RE: **Petition No. 1372** – Derby Fuel Cell, LLC petition for declaratory ruling, pursuant to Connecticut General Statutes §4-176 and §16-50k, for the proposed construction, maintenance and operation of a 14.0-megawatt fuel cell facility and associated equipment to be located at 200 Roosevelt Drive, Derby, Connecticut.

Pursuant to the Council’s request dated June 11, 2019, enclosed on behalf of Derby Fuel Cell, LLC (the “Company”) are an original and 15 copies of the Company’s responses to the Council’s questions 1-36 in the above-referenced matter. The Company is submitting its confidential response to Interrogatory CSC-36 under seal, along with a Motion for Protective Order, which is being filed simultaneously herewith.

Interrogatory CSC-1

EXHIBIT A

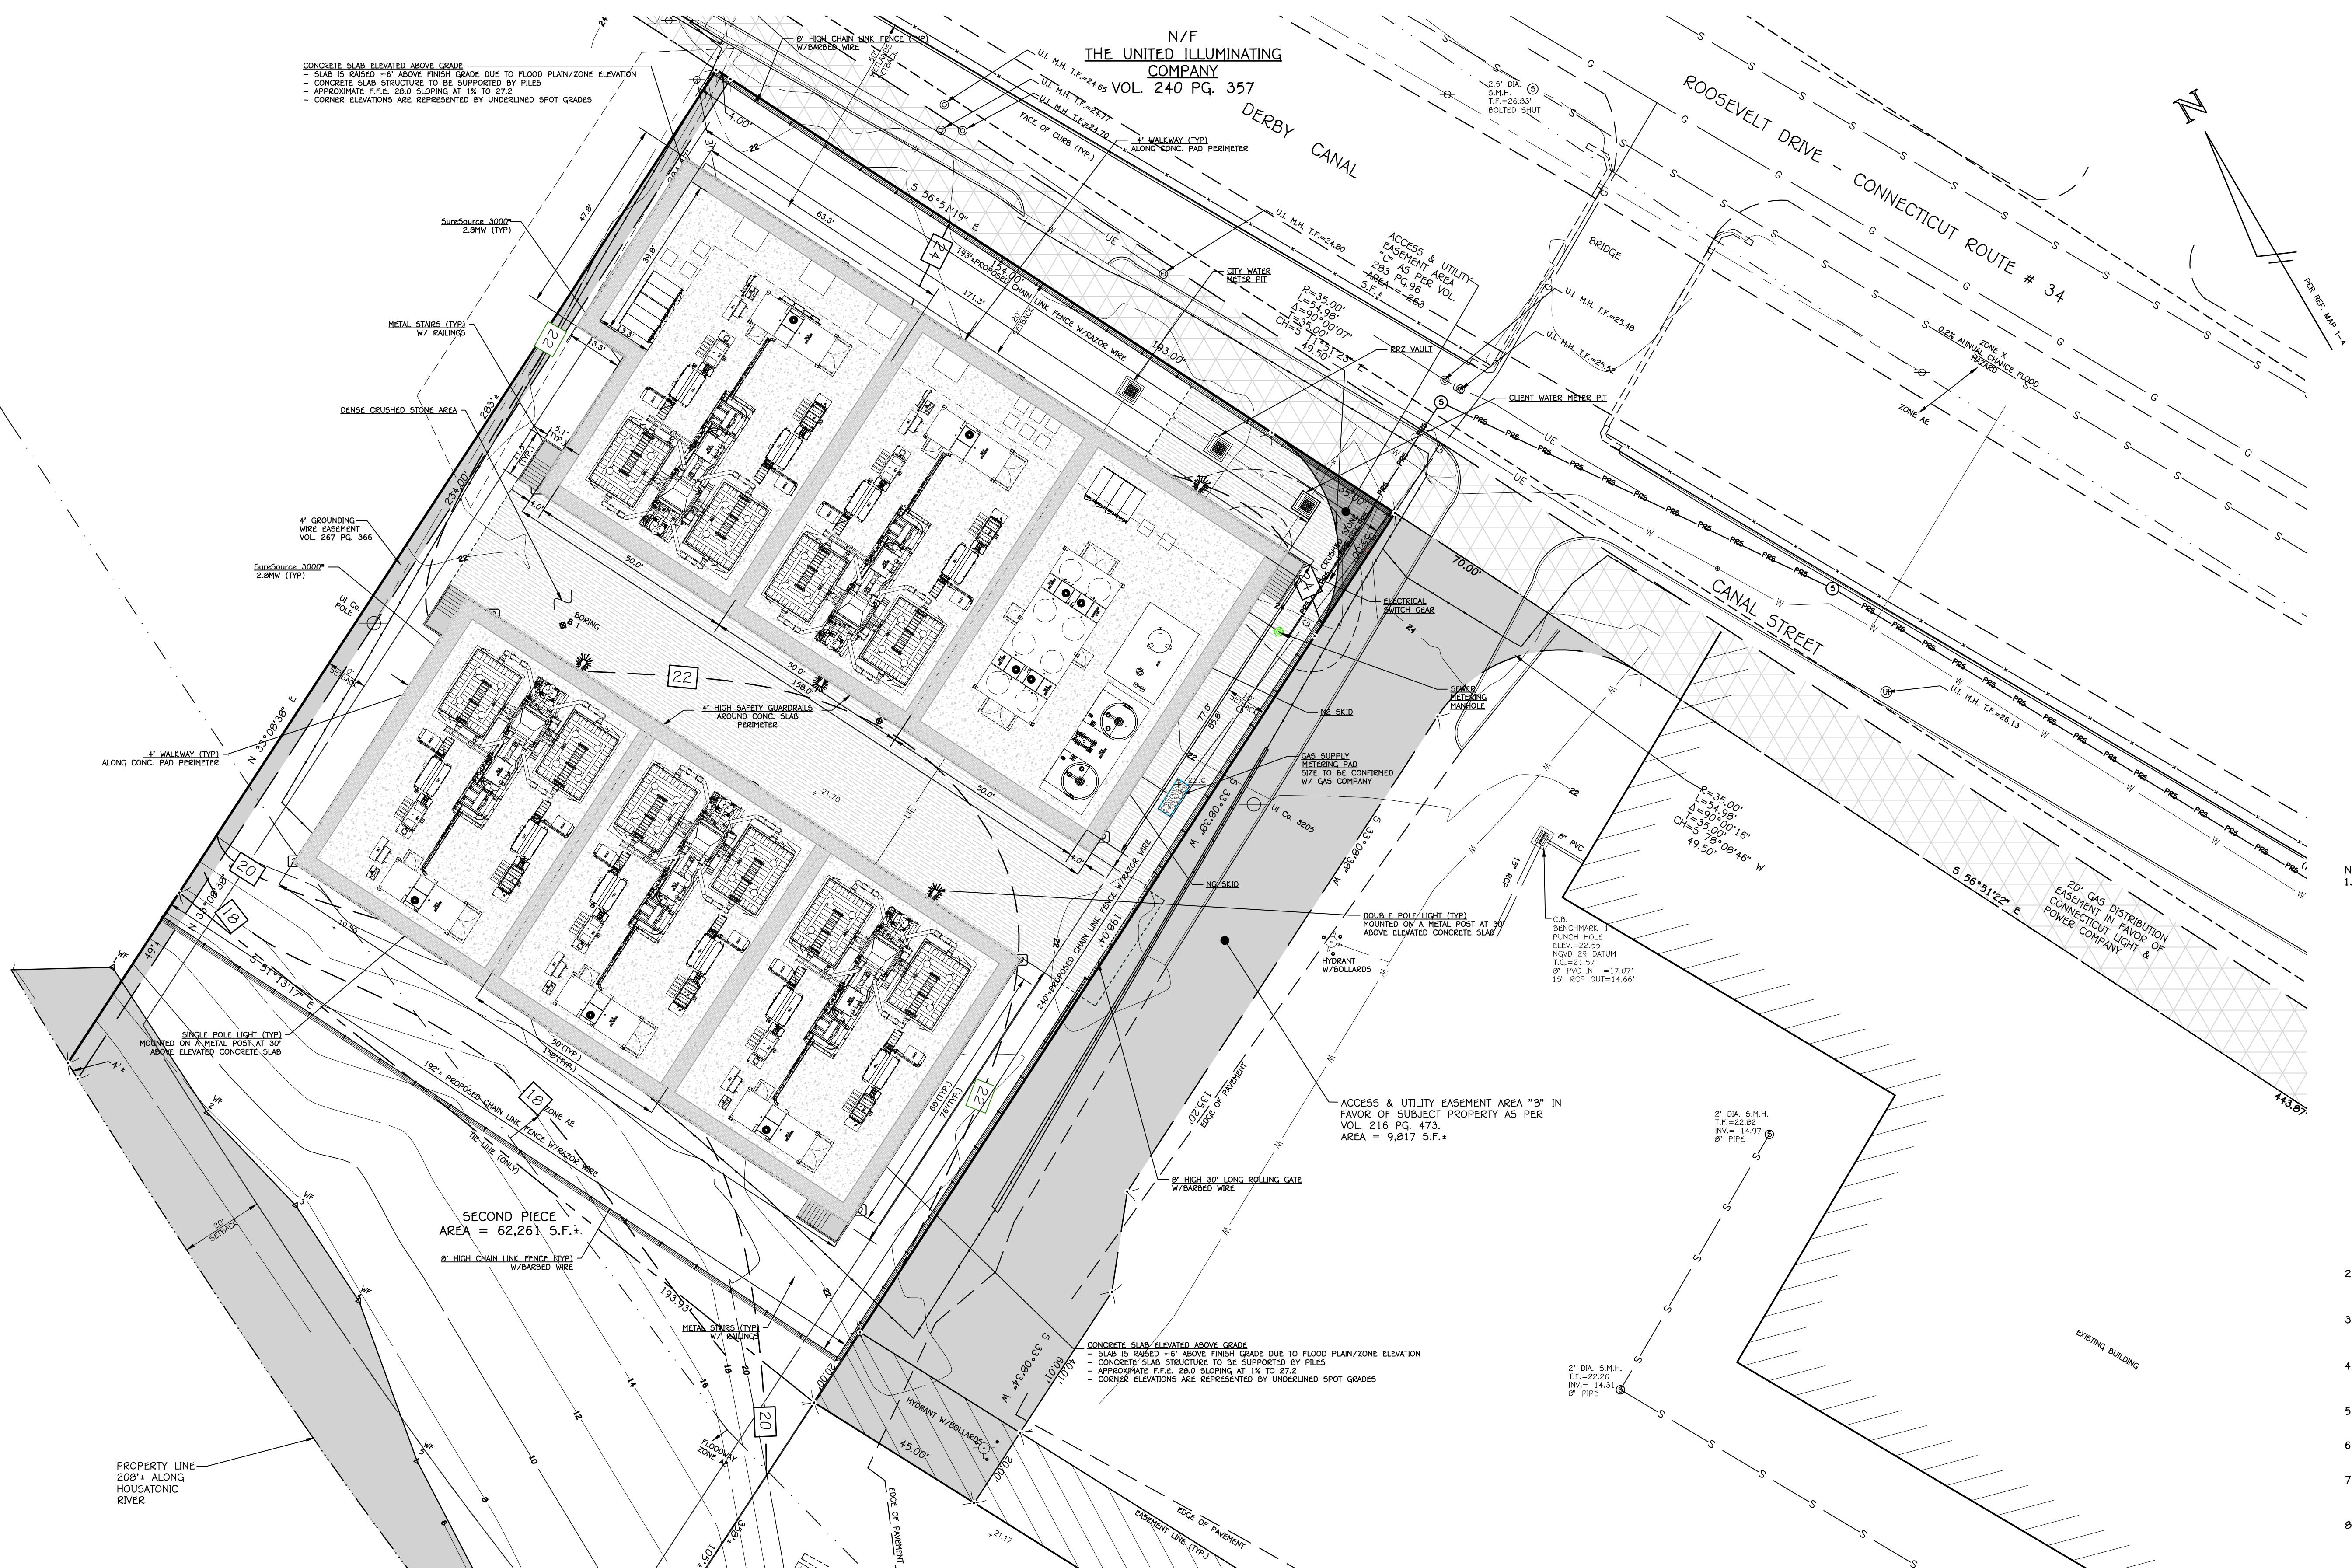
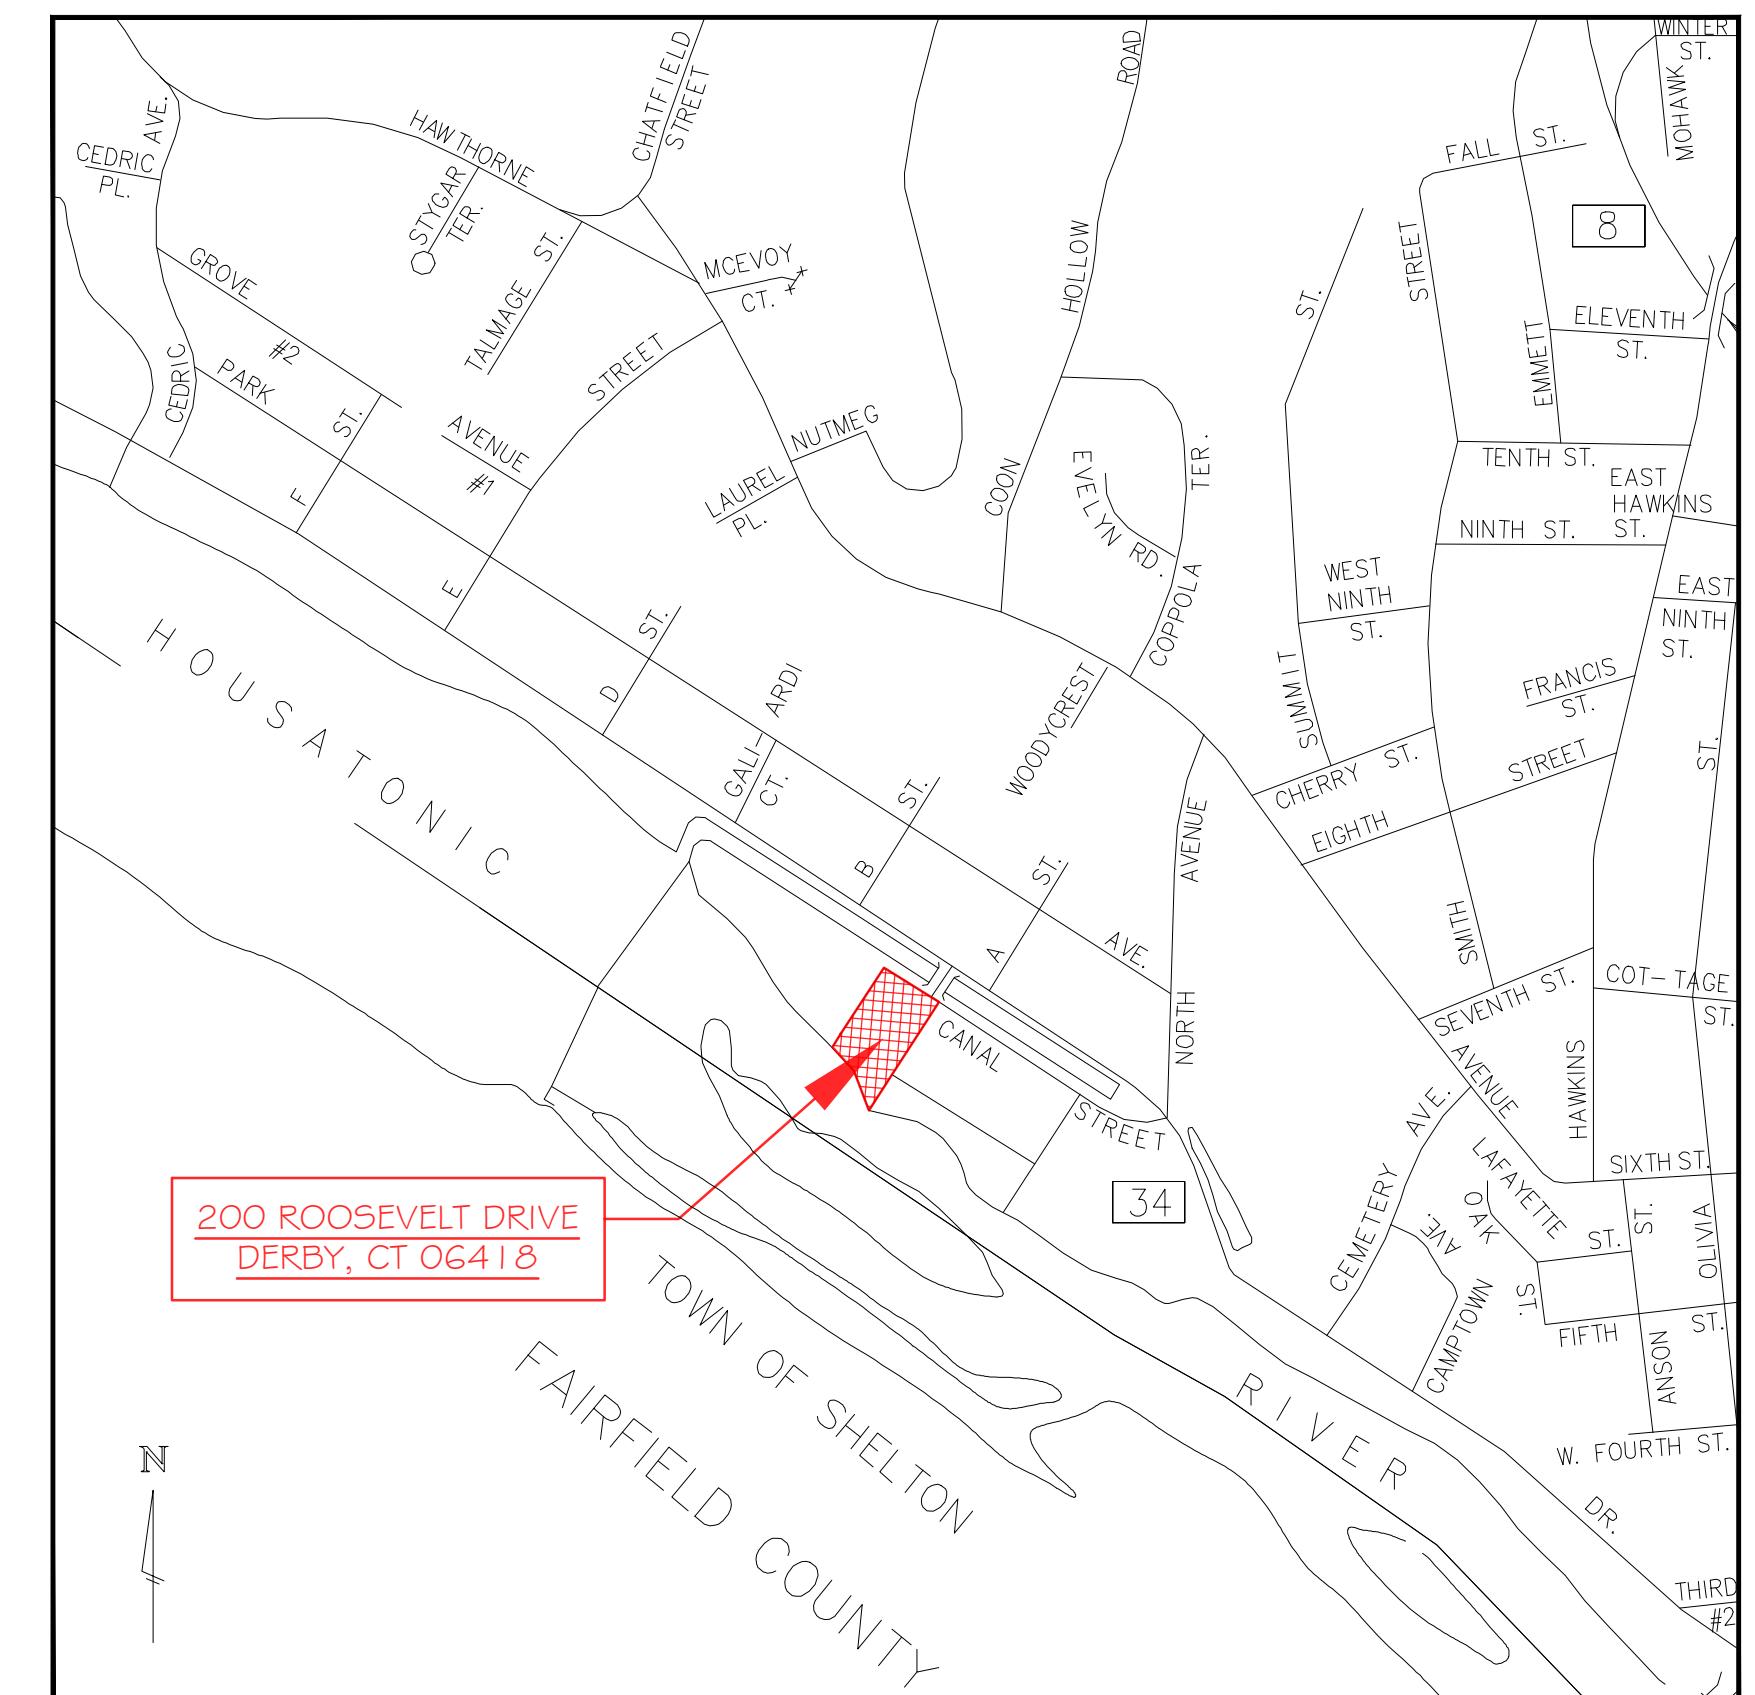
Q-CSC-4 Provide a clear copy of Figure 1 and Drawing Nos. C-001 through C-004 from the Petition, and depict the wastewater connection on Drawing No. C-004. Either 8.5" x 11" or 11" x 17" could be used for the drawing sizes.

A-CSC-4: **A copy of Figure 1 (Site Development Plan) and Drawing Nos. C-001 through C-004 are attached hereto as Exhibit A.**

EXHIBIT C

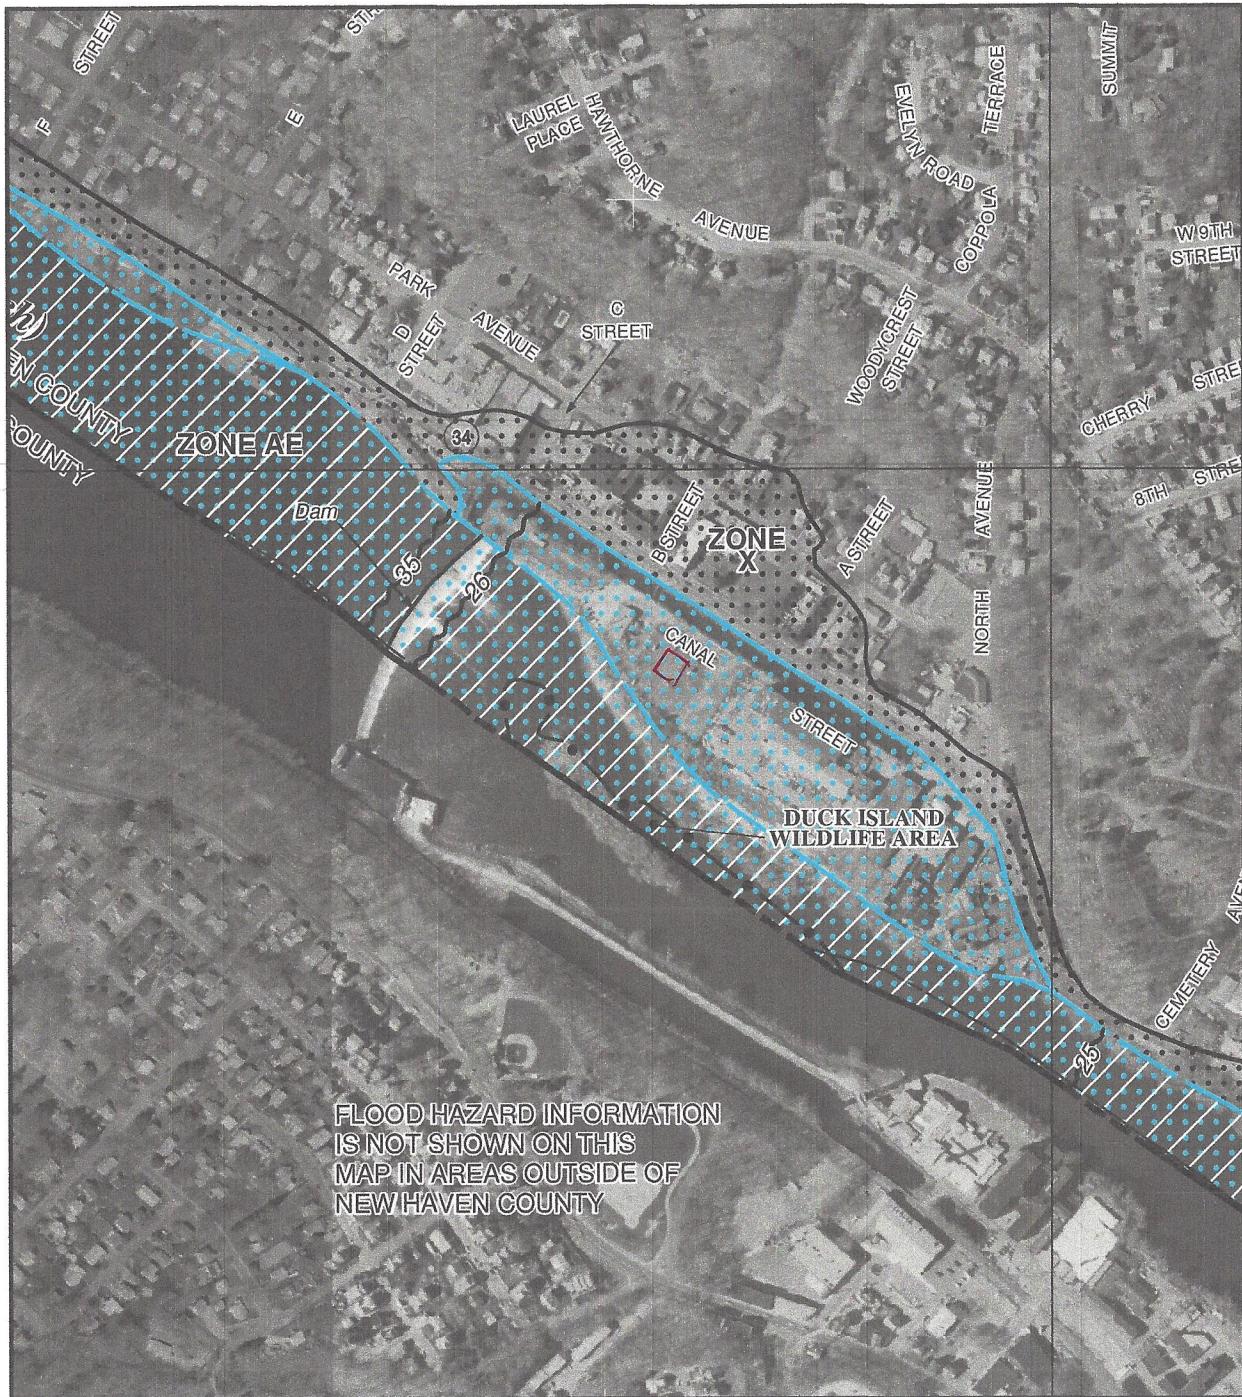
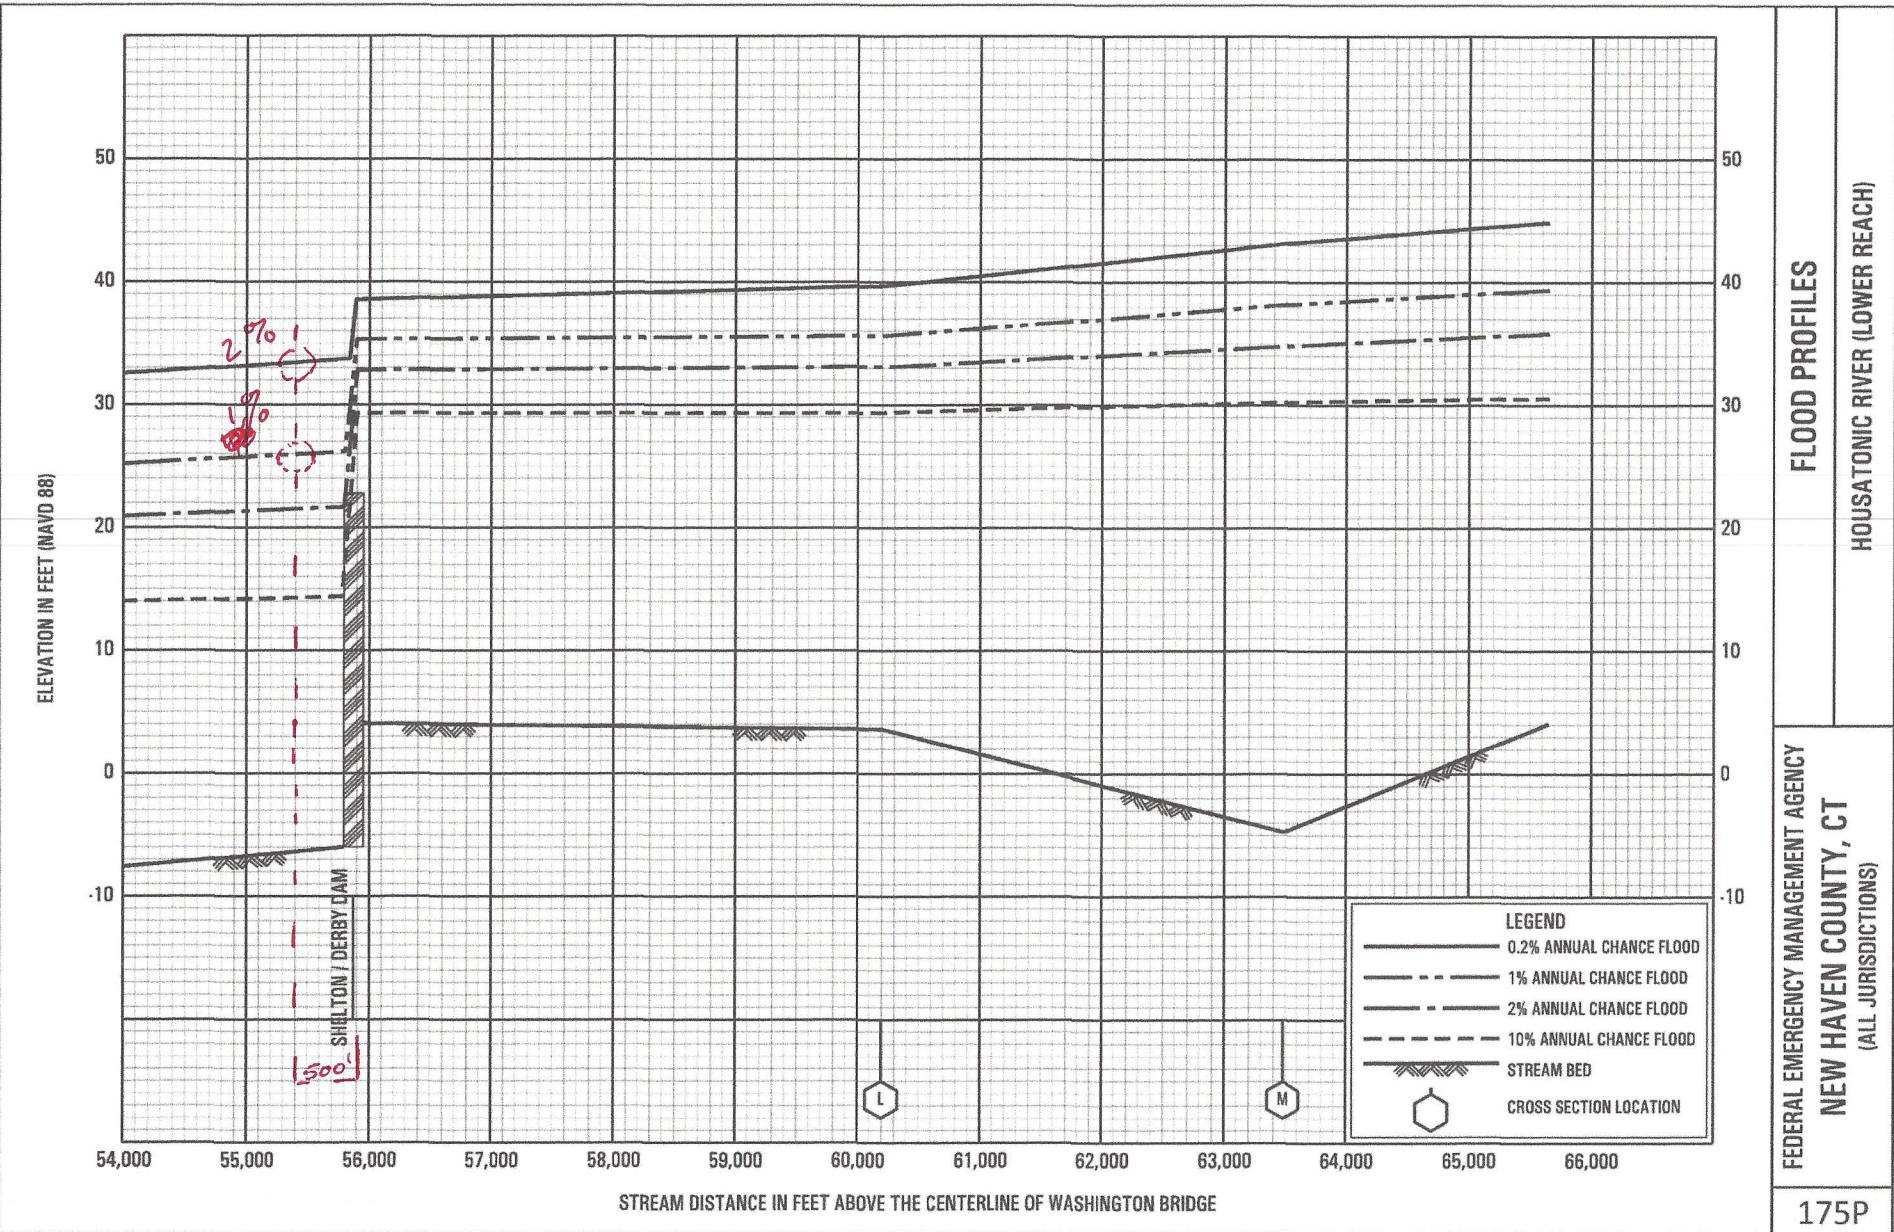
Q-CSC-9 Page 4 of the Petition notes that, “The Project will be elevated approximately six feet above grade to account for the 100-year floodplain and zone elevation.”

- a) Please provide a FEMA flood map showing the proposed facility location and flood zone designation.

A FEMA flood map showing the proposed facility is attached hereto as Exhibit C.
